**MEMORANDUM
04-05**

RE: Standard Drawing No. 604-SWCR-2, Sidewalk Curb Ramps General Notes and Details

**TRUNCATED DOMES USED
IN DETECTABLE WARNINGS**

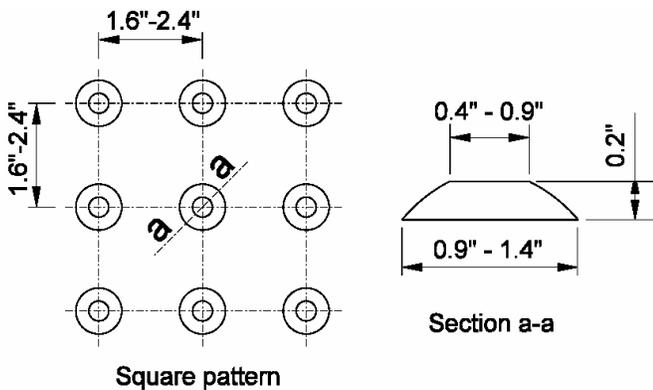
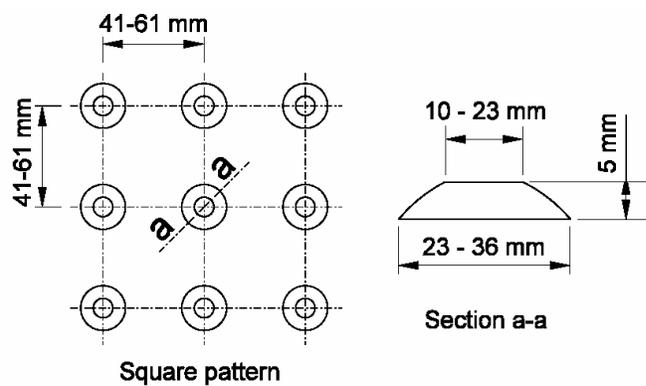
On Standard Drawing 604-SWCR-02, Sidewalk Curb Ramps, the diagram on the truncated domes are not consistent with the Code of Federal Regulations.

Dome Spacing: Truncated domes in a detectable warning surface shall have a center-to-center spacing of 1.6 in. (41 mm) minimum and 2.4 in. (61 mm) maximum and a base-to-base spacing of 0.65 in. (16 mm) minimum, measured between the most adjacent domes on square grid.

The standard drawing will be changed to reflect the following diagram and this pattern is effective immediately.
